Certificate of Appropriateness Urban Design Commission

James Walker and Thomas Oliver (Alpha Family Group) | E.A. Wealth Management, LLC
1101 E Rosedale St (UDC-2025-250)

On **October 24, 2025**, Urban Design Review Staff **APPROVED** a request for a Certificate of Appropriateness to rehabilitate a one-story commercial property in the Near Southside District.

PROPOSED
FLOOR
PLAN

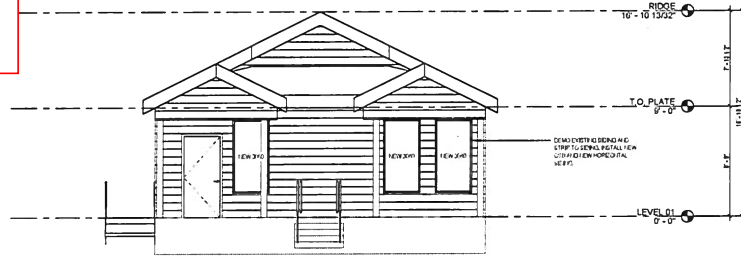
— EXISTING
METAL
STRUCTURE TO
BE
DEMOLISHED

Must obtain encroachment agreement for building permit because existing stair encroaches into ROW

Bushes must be from approved list in §6.301 Table A
